Work Order ID 79745

Item Name: Crosstube Turning Detail

DART AEROSPACE LTD HAWKESBURY, ONTARIO, CANADA	
DRAWING NO. D407-667-245	REV. F SHEET 1 OF 4
TITLE CROSSTUBE ASSY (407 HIGH AFT)	SCALE NTS
COPYRIGHT © 2002 BY DART AEROSPACE LTD THIS DOCUMENT IS PRIVATE AND CONFIDENTIAL AND IS SUPPLIED ON THE EXPRESS CONDITION THAT IT IS NOT TO BE USED FOR ANY PURPOSE OR COPIED OR COMMUNICATED TO ANY OTHER PERSON WITHOUT WRITTEN PERMISSION FROM DART AEROSPACE LTD.

DRAWING NO. D407-667-245	TITLE CROSSTUBE ASSY (407 HIGH AFT)	REV. F	DART AEROSPACE LTD ENGINEERING ORDER		D.E.O. NO. D407-667-245-F-1	SHEET NO. SHEET 1 OF 2	SCALE NTS
DRAWN	CHECKED	MFG. APPR.	APPROVED	DE APPR.			
DATE 11.04.08	DATE 11.04.12	DATE 11.04.12	DATE 11.04.12	DATE 11.04.12	DATE 11.04.12

DRAWING NO. D407-667-245	TITLE CROSSTUBE ASSY (407 HIGH AFT)	REV. F	DART AEROSPACE LTD ENGINEERING ORDER	D.E.O. NO. D407-667-245-F.1	SHEET NO. SHEET 2 OF 2	SCALE NTS
DRAWN	CHECKED	UP	MFG. APPR.	APPROVED	DE APPR.	
DATE 11.04.08	DATE 11.04.11		DATE 11.04.12	DATE 11/04/12	DATE 11.04.12

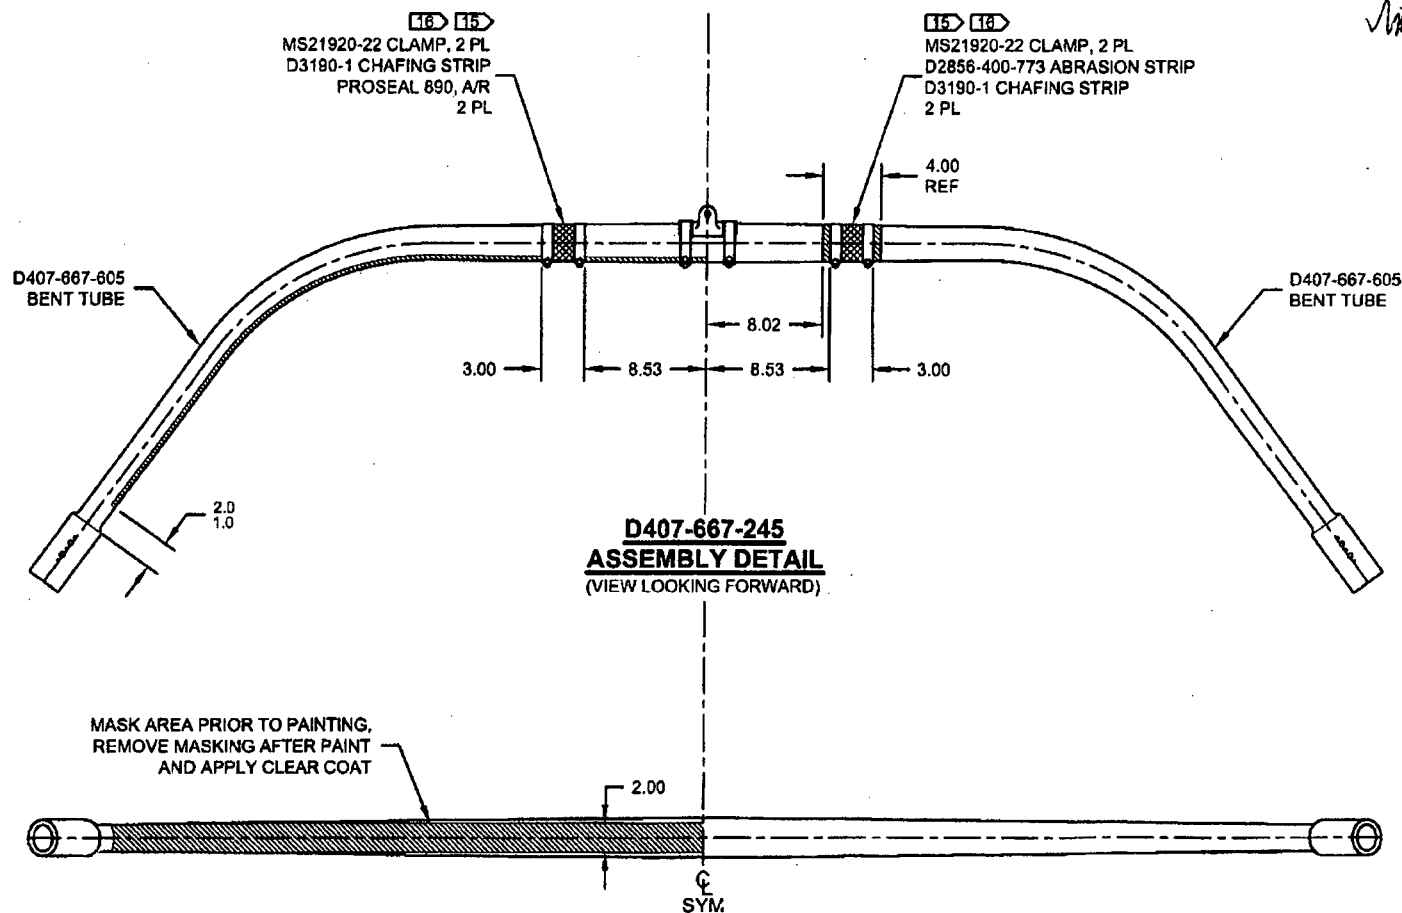
NOTES 2 AND 15, SHEET 1 ARE AMENDED AS FOLLOWS:

- 2) FINISH: CHEMICAL CONVERSION COAT PER DART QSI 005 4.1
PRIME INSIDE AND OUTSIDE PER DART QSI 005 4.2
MASK UNDERSIDE OF CROSSTUBE AS SHOWN (HATCHED AREA) AND
PAINT OUTSIDE PER DART QSI 005 4.2
REMOVE MASKING AND APPLY CLEAR COAT
- 15) APPLY A THIN COAT OF PROSEAL 890 ON INSIDE CONCAVE SURFACE OF D3190-1
CHAFING SHIELDS AND LET CURE PER MANUFACTURER'S INSTRUCTIONS. INSTALL
PROSEAL D3190-1 CHAFING SHIELDS ONTO CROSSTUBE BY APPLYING A THIN COAT
OF PROSEAL 890 ONTO CROSSTUBE. BE SURE TO ELIMINATE ANY AIR GAPS.

IS:

WAS:
